Questions/Comments on ECE/TRANS/WP.29/GRSG/2019/10

IG VRU-Proxi, 8th Meeting

FoV rear-end pole location

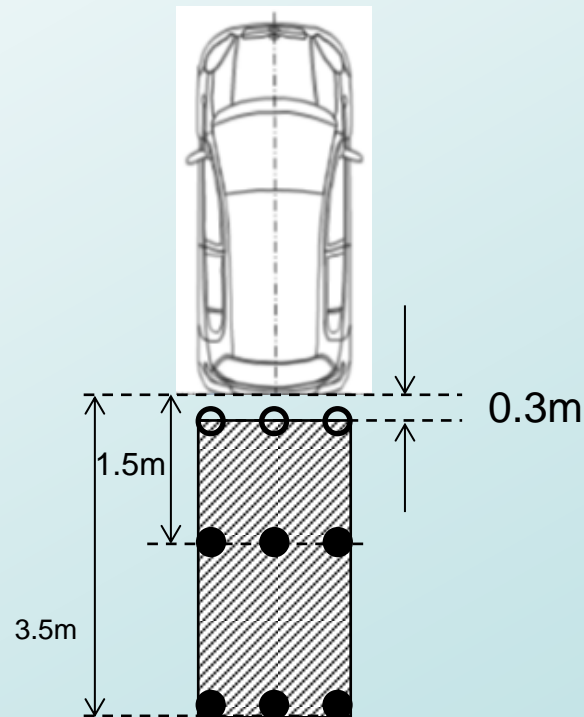
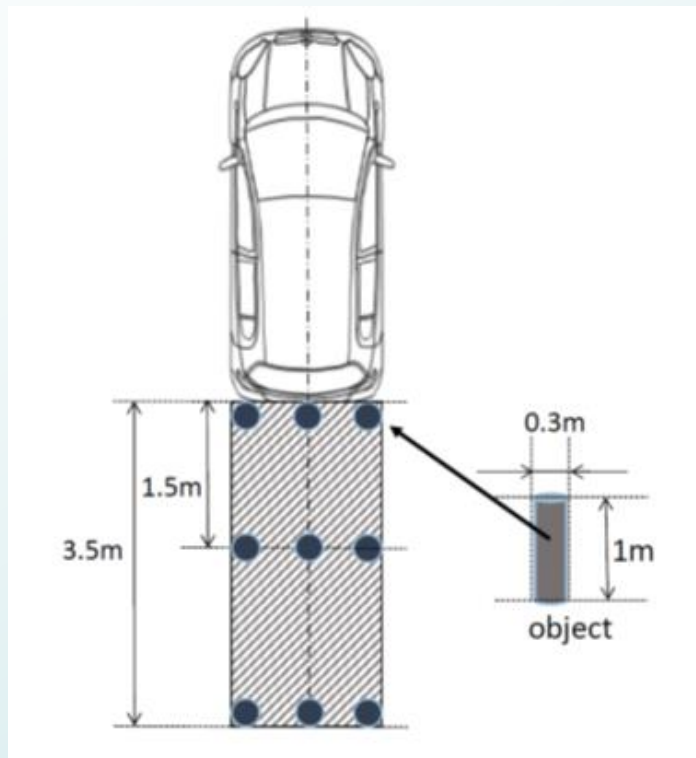
15.2.4.8.1.

(a) A transverse vertical plane through the outermost point of the rear of the vehicle;

to be

(a) A transverse vertical plane **300 mm** behind of the outermost point of the rear of the vehicle;

Cf. FMVSS 111

FoV rear-end pole location

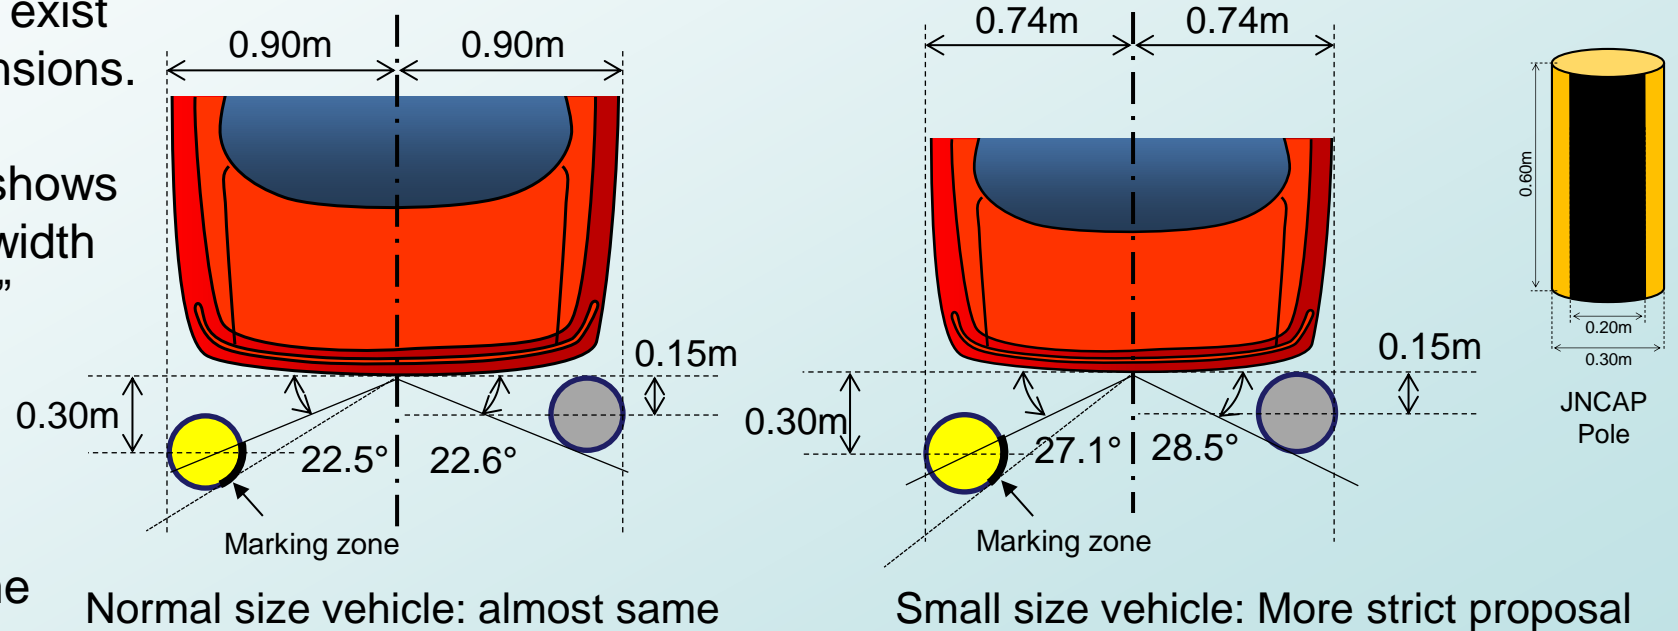
1) Proposal is actually 0.15m gap range of pole existence. VRU can not exist in this space due to body dimensions.

2) Comparison of visibility of pole shows almost the same of JNCAP 20cm width markings. "To see 20 cm markings" seems the same as "at least part of each cylindrical objects" at this position (very small viewing angle).

3) This condition is almost the same as Audible warning system (sonar) test procedure in Annex 13 (Evaluation start from 0.2 m as per ISO17386 also used in India.)

4) Korea & US both identified space between monitoring area and rear end of vehicle

Combination of CMS of Class VI and Class VIII

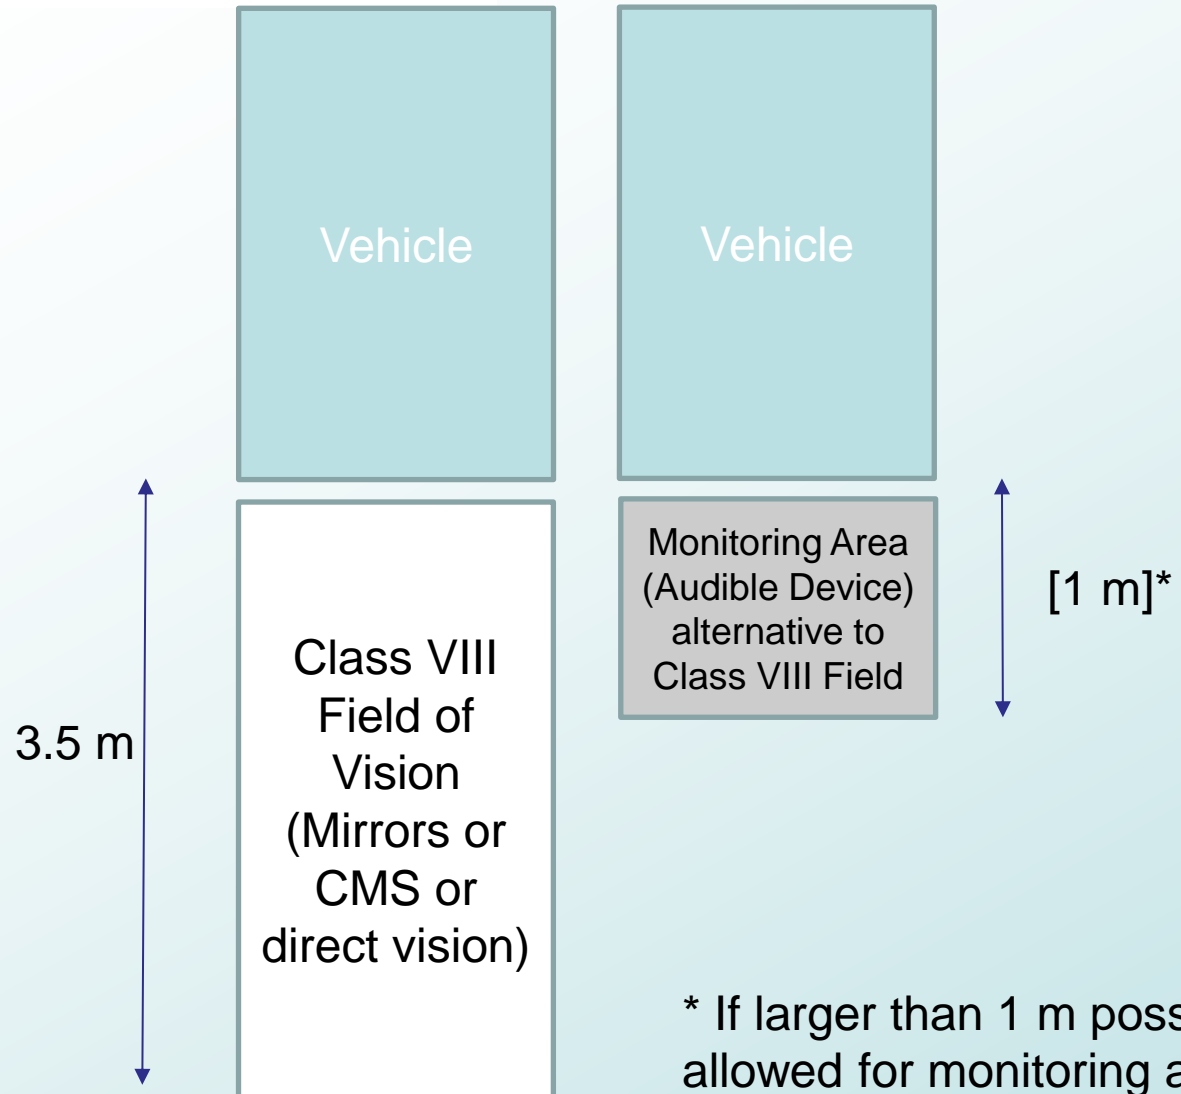
- Today applications use same screens for class VI (front view) and rear view (until now unregulated).
- There is no overlap situations based on the description of the the application. Class VI is for forward with speed above 10 km/h, Class VIII is vor backward driving.
- If combination is not allowed, an additional screen is needed, which even in the instrument panel of trucks is a space issue, since the sreen needs tobe in direct view of the driver. Also an additional screen might cause higher distraction.

Paragraph 15.2.1.1.2., amend to read:

"15.2.1.1.2. In the case a camera-monitor system is used for rendering (the) field(s) of vision, the relevant field(s) of vision shall be permanently visible to the driver when the ignition is on or the vehicle master control switch is activated (whichever is applicable). However, when the vehicle is moving forward at a speed above 10 km/h or backwards, the monitor or the part of the monitor intended for rendering the Class VI field of vision may be used for other information **(excluding Class VIII)**. **However, when the vehicle is moving forward, the monitor or the part of the monitor intended for rendering the class VIII field of vision may be used for other information** . Multiple images may be used or displayed provided that the monitor has been approved in this mode.

~~Furthermore, in the case of a camera-monitor system intended for rendering the Class VIII field of vision, it may be such that the relevant field of vision is permanently visible to the driver only when the vehicle is moving backwards."~~

Alternative: Class VIII field or Obstacle Detection

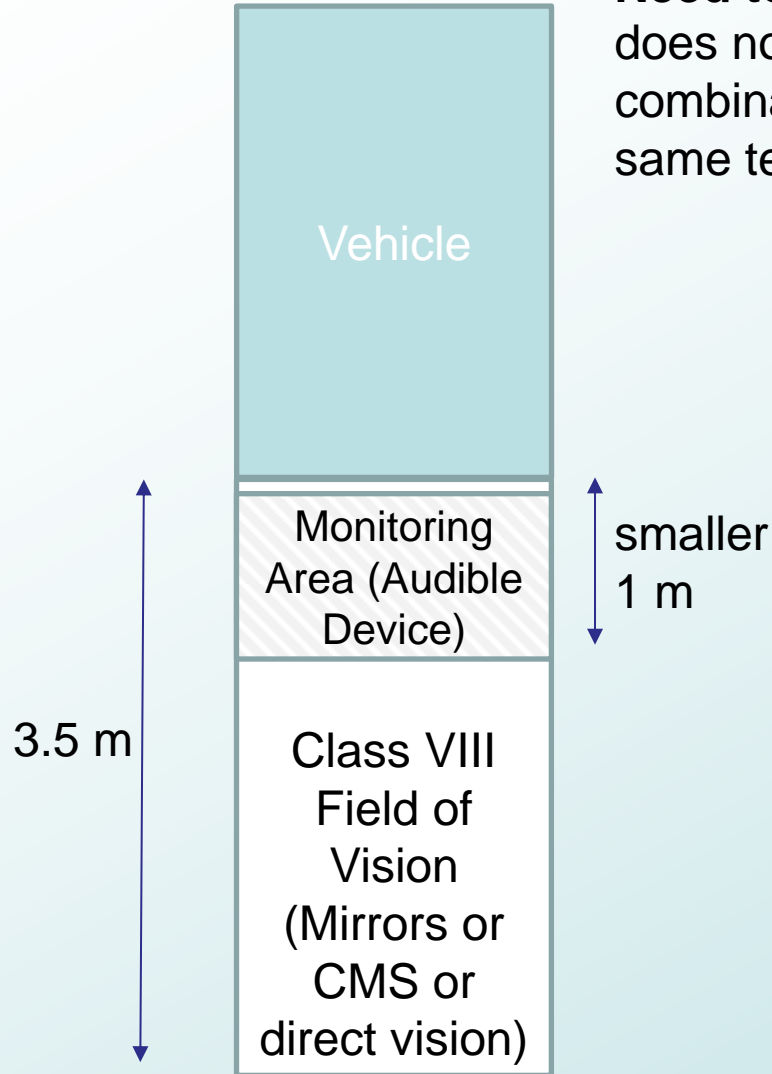
Regulation needs a clear statement that monitoring is equivalent to a vision device field of vision and that this physical area is not the same.

Current draft text: „15.2.4.8.2. ... In addition, the requirement may be met using a combination of mirrors of Class VIII and other Class(es) **or using an obstacle detection system.**“

This statement mixes combination and replacement with obstacle detection system.

➔ New Text Proposal on Slide 8

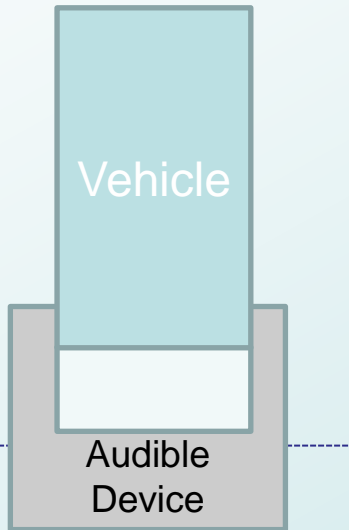
Can the audible device cover more than the regulatory Monitoring Area ?

5.1. Monitoring area

The maximum detection distance in Clauses 5.4.2 and 5.4.3 of ISO 17386 :2010 shall be [1.0] m (Class R2).

NOK

Proposal: The **required** detection distance ... shall be [1.0] m **maximum** (Class R2).

For clarity recommended to add a picture of the detection zone (width of vehicle x 1m)

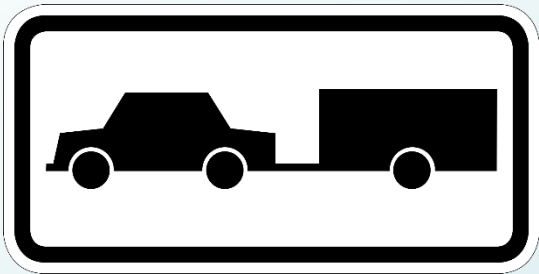
Does the test have to be repeated for each grid square in the monitoring area or only once ?

- § 4: detection latency 0.6 s: in deviation of ISO 17386 the poles are placed on the grid prior selection of rear gear „**locate the test object behind the vehicle**”
→ **1 test spot ? Which ? Center of Area, Border ?**
- § 5.2 (minimum detection rate) „**There shall be no undetected hole larger than a square consisting of two-by-two grids.** “
→ every second grid of the defined 0,1x0,1 grids. Example: vehicle with 2 m width the monitoring area is 0.8 m times 2 m, which gives 160 grids, which results in **minimum 40 tests** !

Any Trailers

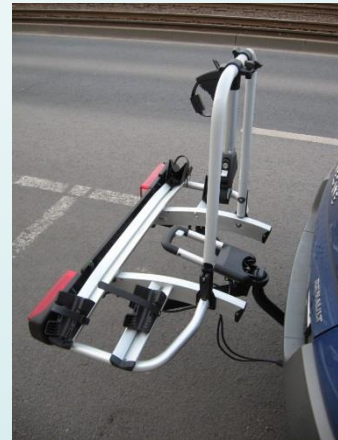
Does this cover any equipment to trailer hitch ?

This could be manual or automatic deactivation.

What about equipment not using the trailer hitch ?

This could be only manual deactivation.
